**THE GARDENS AT NORTH  
CAREFREE  
FINAL DRAINAGE REPORT  
EL PASO COUNTY, COLORADO**

PROJECT NO. 187608744

January 21, 2019

**PCD File No: SF 195**

Project: **Gardens at North Carefree**  
 Inlet ID: **Proposed Type R Inlet - DP A**

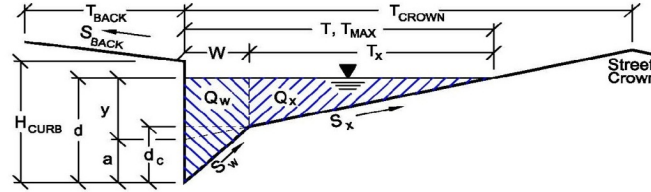
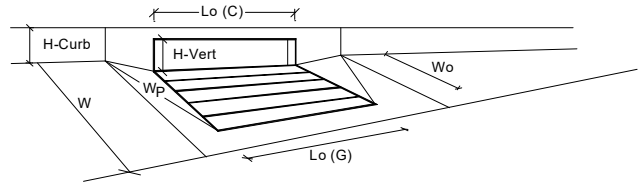
Please show the complete inlet calculations as done in the first submittal.

## Storm System 1

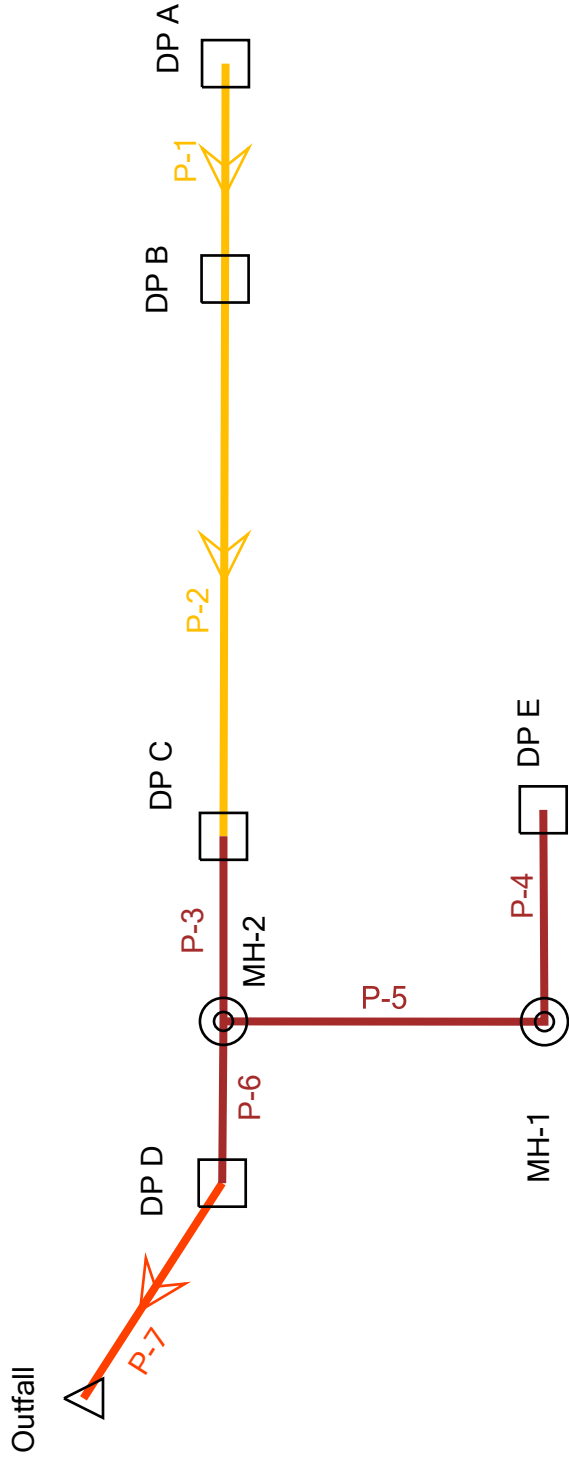
Why is the flow different from what is shown on your design point calculations?

**Storm System 1 - 5 Year**

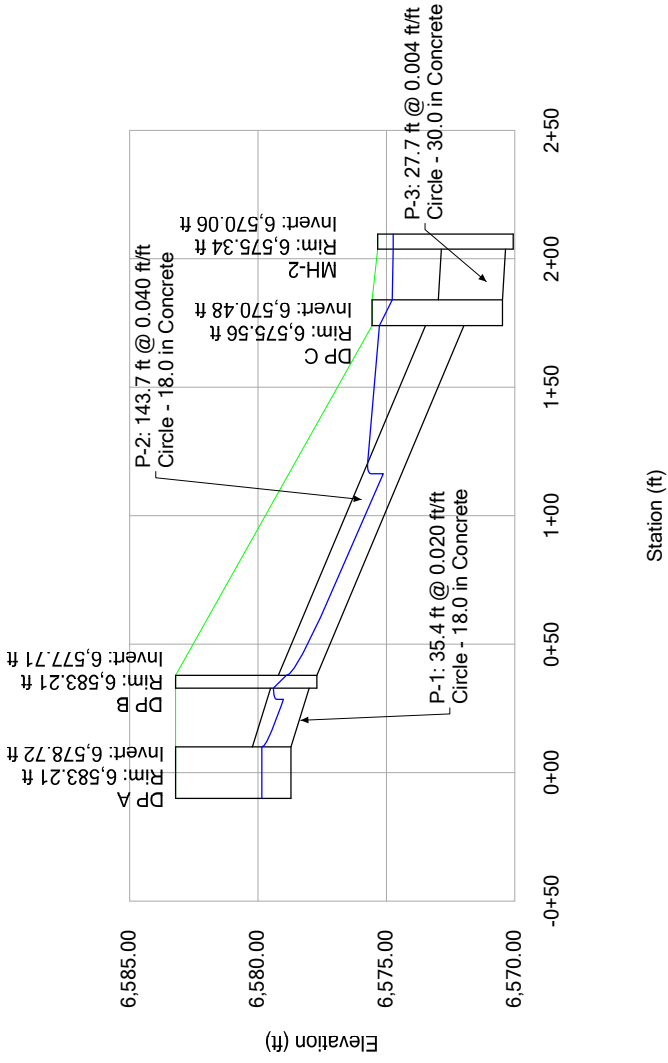
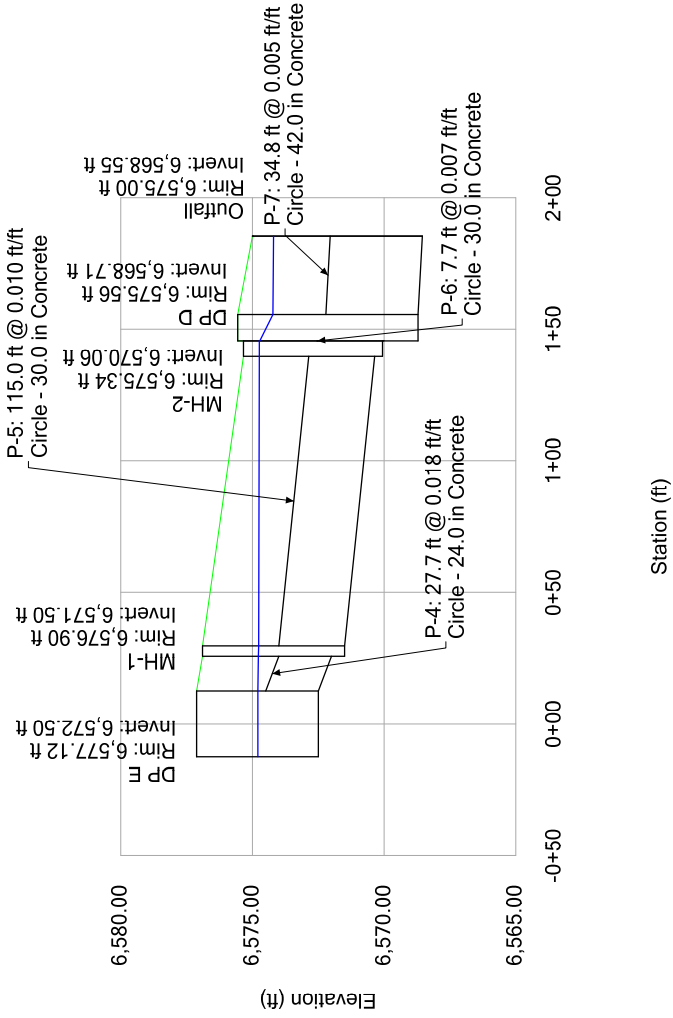
Why is the flow different from what is shown on your design point calculations?

**Storm System 2 - 100 Year**

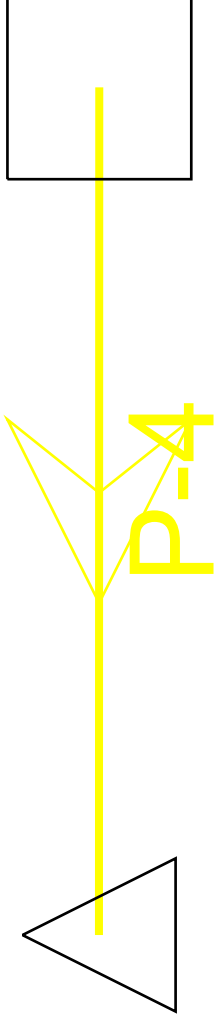
Why is the flow different from what is shown on your design point calculations?

**Storm System 2 - 5 Year**

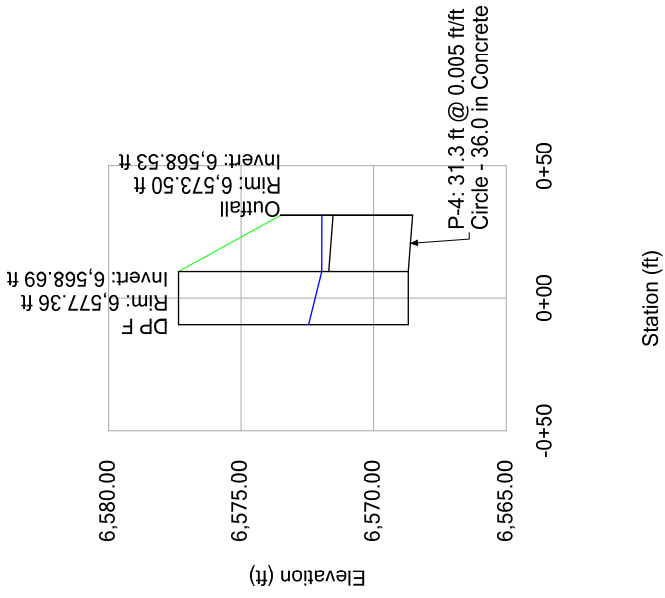
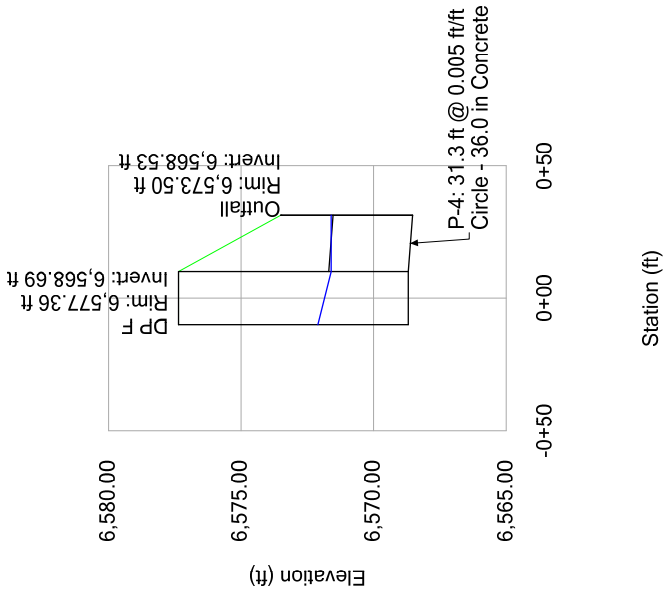
Why is the flow different from what is shown on your design point calculations?

## South Pond

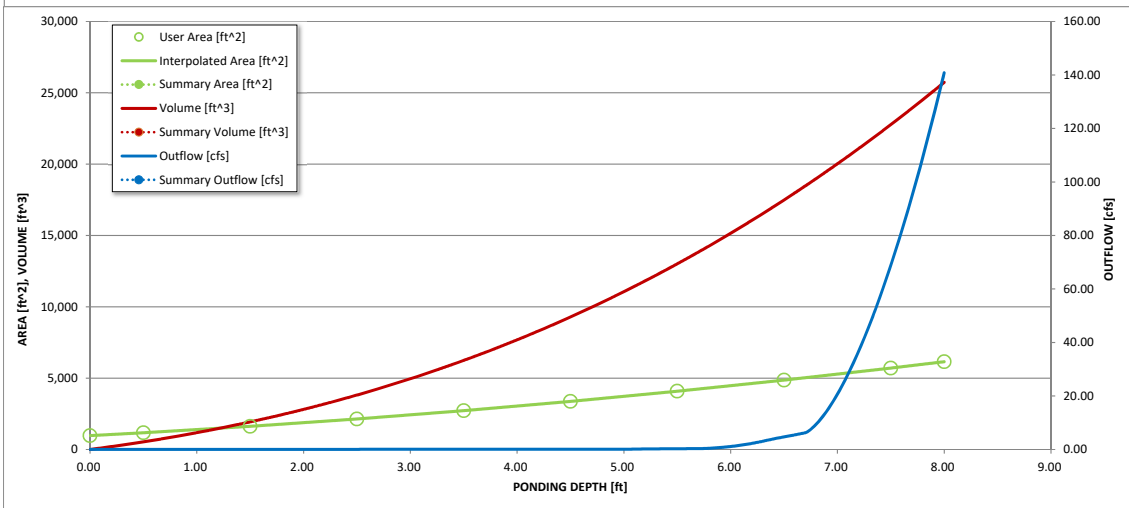
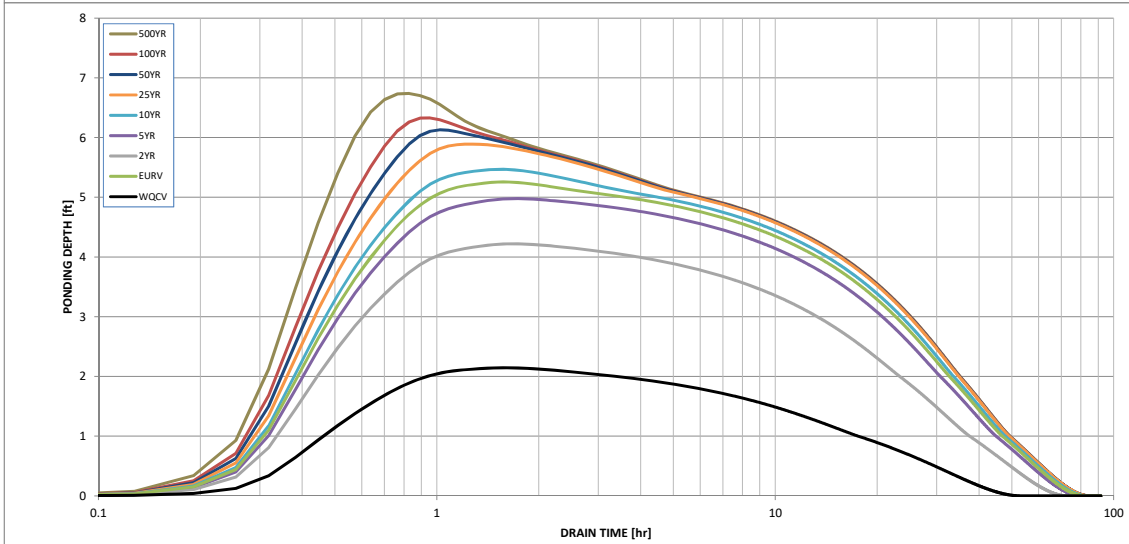
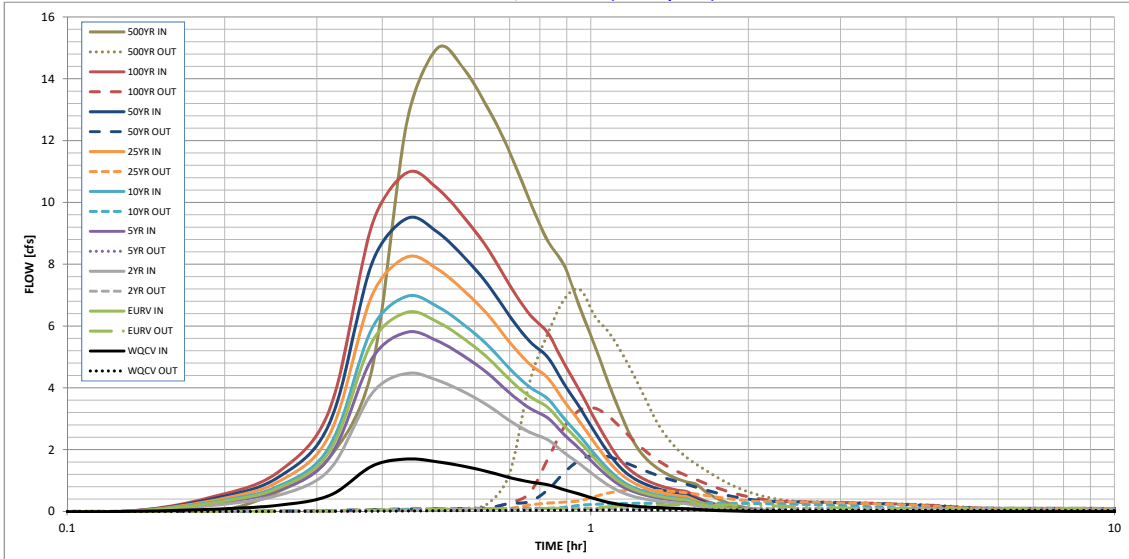
WQCV shall drain in 40hrs. Adjust design accordingly
